SUBJECT: **NEW VEHICLE DEMONSTRATION / DELIVERY HOLD - Safety Recall 19S27**
 Certain 2019 Model Year Fiesta Vehicles
 Front Brake Caliper Seal Contamination

CERTAIN 2019 MODEL YEAR FIESTA VEHICLES — FRONT BRAKE CALIPER SEAL CONTAMINATION

FIGURE 1

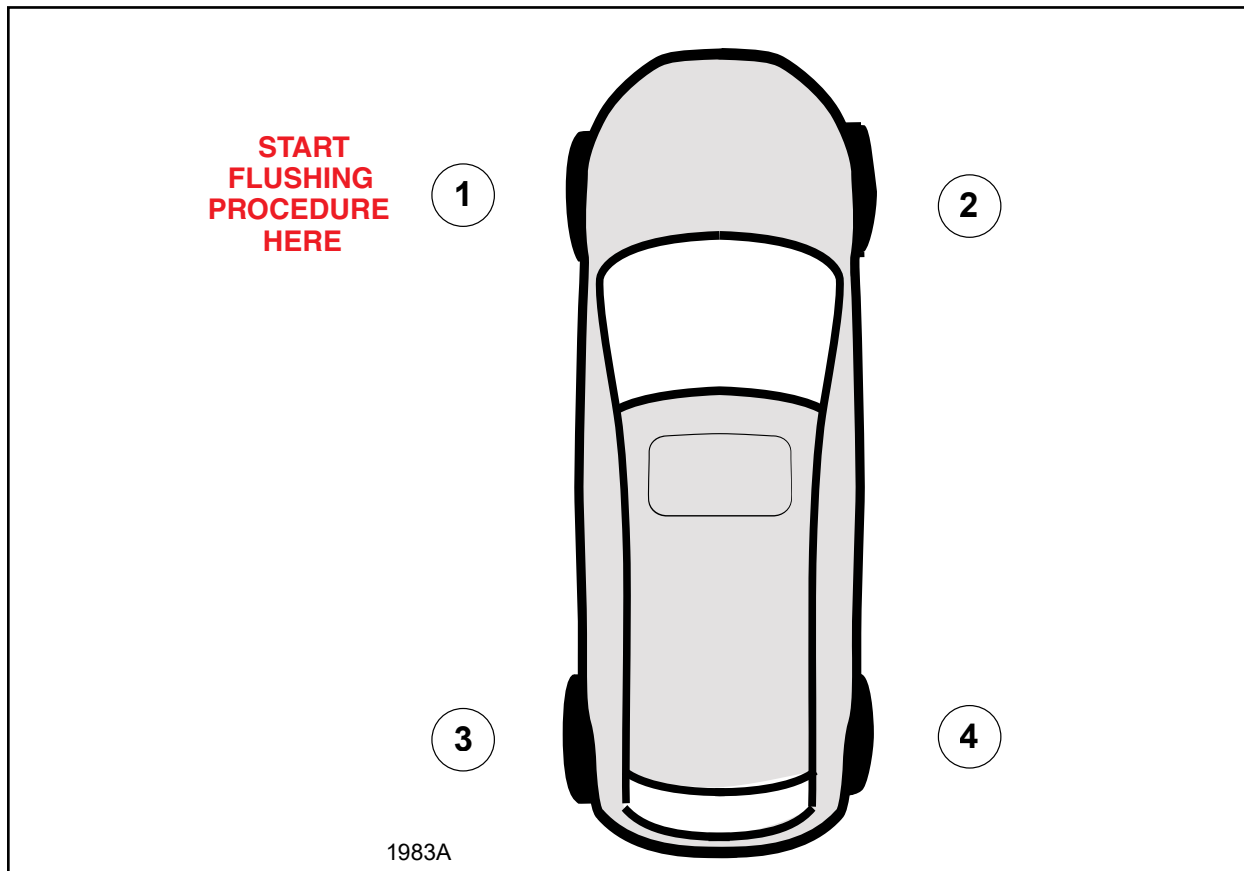
- While flushing the brakes follow the bleed order shown in Figure 1. This bleed order is unique to this recall procedure. See Figure 1.
- Flush 400 ml of fluid on each side of the front brakes.
- Flush 200 ml of fluid on each side of the rear brakes.

FIGURE 2

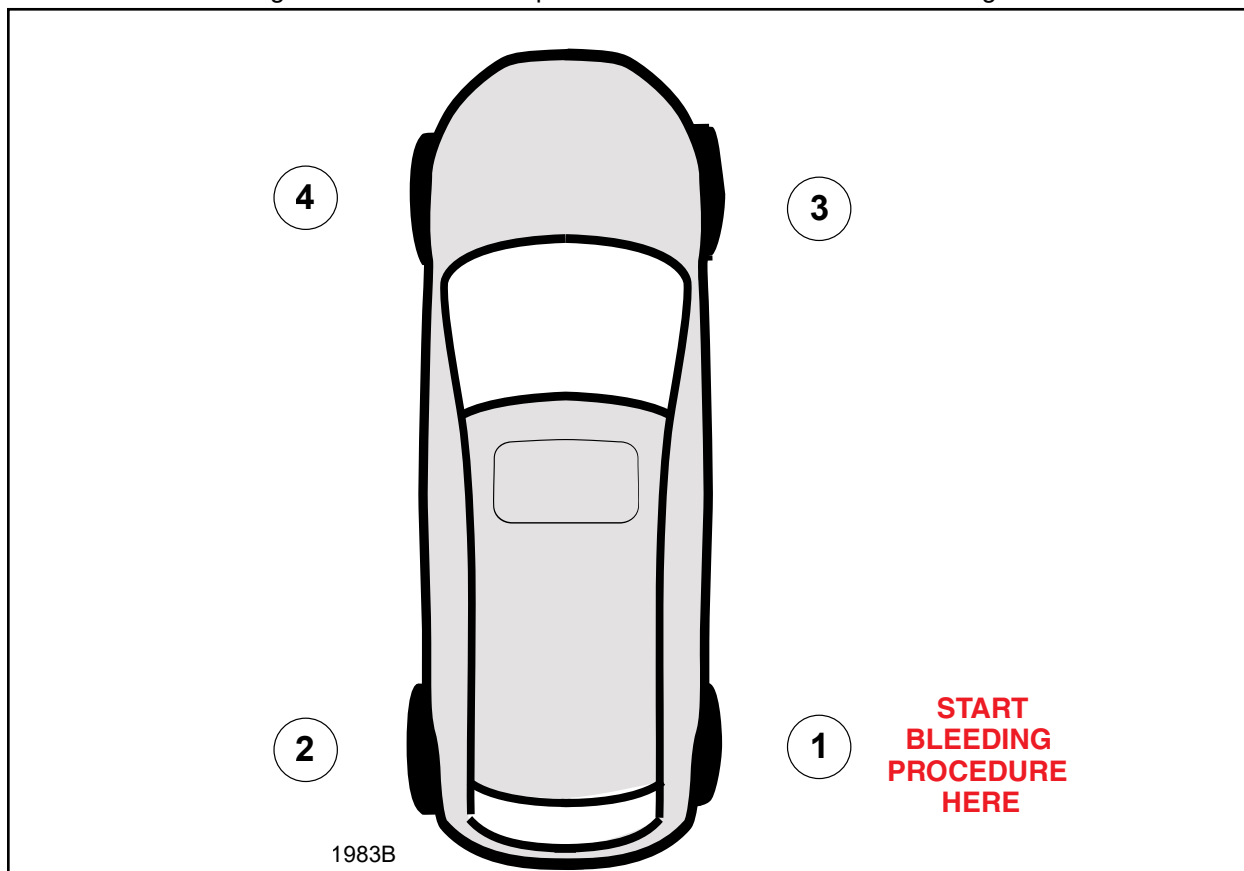
- While bleeding the brakes in this step follow in the bleed order shown in Figure 2.
